DART SERVICE INSTRUCTION

TO AMEND IIN-D412-809 REV. A,
AND ICA-D412-809 REV. 0
REF. TCCA SSTC: C-LSH11-100/D

The purpose of this DSI is to provide additional installation instructions for the Bell 412EP Avionics Modification outlined in IIN-D412-809 Rev. A to obtain positive margins per SUB-D412-809-1 Rev. A.

2.0 MODIFICATION TO #2 GPS / VHF COMM ANTENNA INSTALLATION

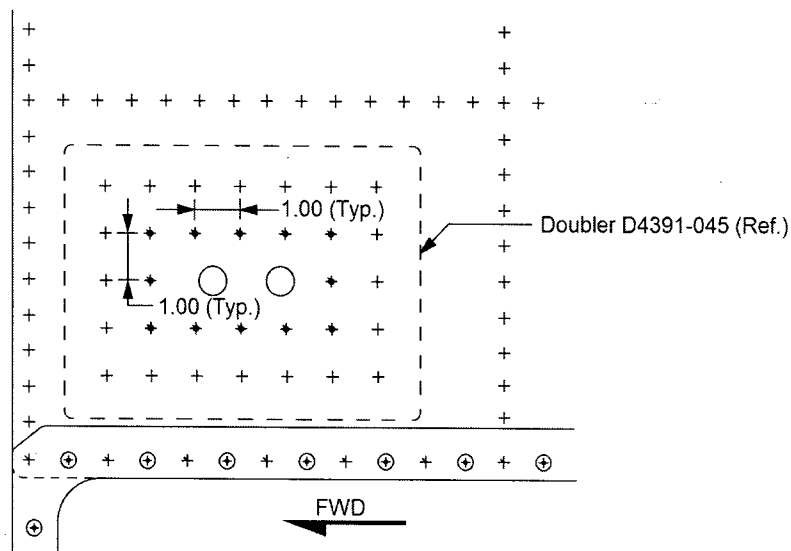
2.1 Remove & retain four MS24693S278 Screws, four NAS1149D0332J Washers, four MS21042L3 Nuts and one Comant CI 2580-200 Antenna located on the cabin roof at STA40 and BL14.

2.2 Install twelve MS20426AD3 Rivets as shown:

- ✦ MS20426AD3 Rivets (NEW)
- ✦ MS20470AD4 Rivets (Existing)

2.3 Re-install the Comant CI 2580-200 Antenna as indicated in IIN-D412-809 Rev. A Section 2.1.6.c through Section 2.1.6.g.

3.0 MODIFICATION TO R/H CREW BECKER ACU6100 INSTALLATION

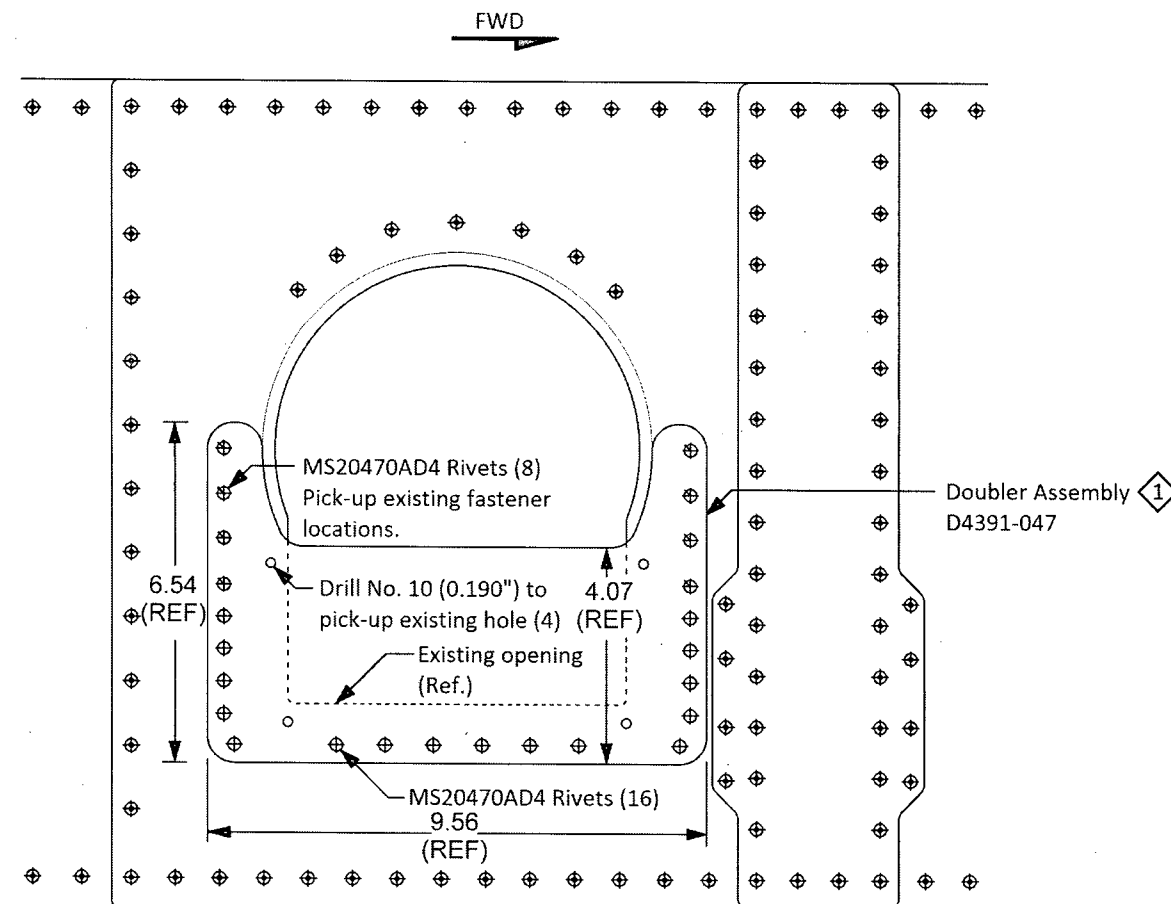
3.3 Fabricate & install Doubler Assembly D4391-047 as shown:

1. Fabricate D4391-047 from 0.040" 2024-T3 Sheet (QQ-A-250/5).
2. Maintain 0.32" minimum edge distance, minimum 0.50" pitch, maximum 1.00" pitch for all MS20470AD4 rivets installed.

3.4 Re-install Bracket Assy D4391-043 (including attached DZUS fastener rails) in accordance with IIN-D412-809 Rev. A Section 2.2.4.b. Substitute AN525-10-7 screws for AN525-10-6 screws if necessary to maintain 2 threads minimum past the anchor nuts included on D4391-043.
